**WEST SUSSEX COUNTY COUNCIL
PLANNING SERVICES CONSULTATION**

SUBJECT: LU/278/17/RES - Approval of Reserved Matters following Outline Permission LU/47/11 for Construction of the southern section of the Lyminster Bypass, including northern and southern roundabouts, surface water drainage and landscaping. Departure from the Development Plan & affects a Public Right of Way.

LOCATION: North Littlehampton Strategic Development Site, Land West of Toddington Park, Toddington Lane, Littlehampton, BN17 7PP.

Barrell Drawing – Tree protection plans

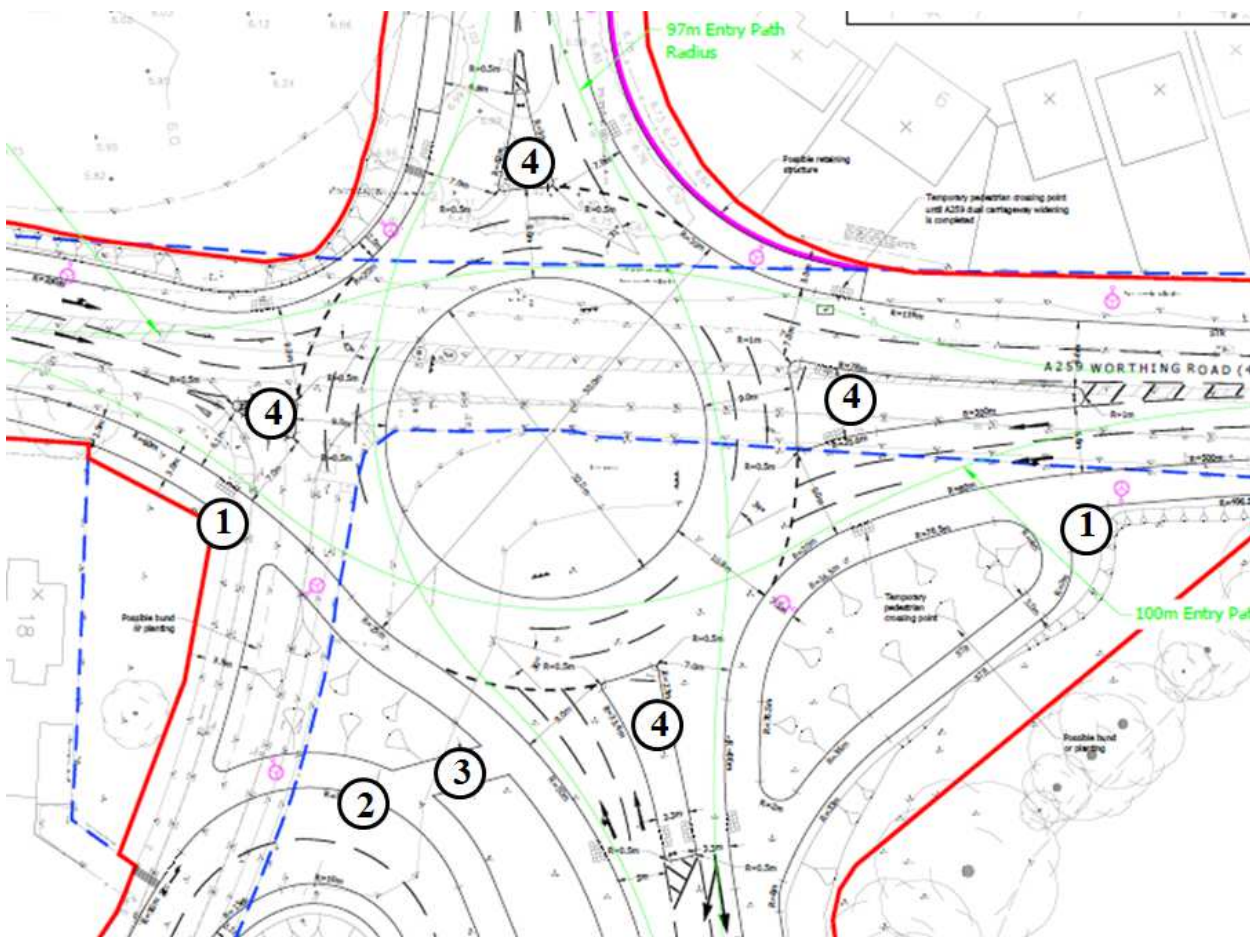
SEE LANDSCAPING COMMENTS.
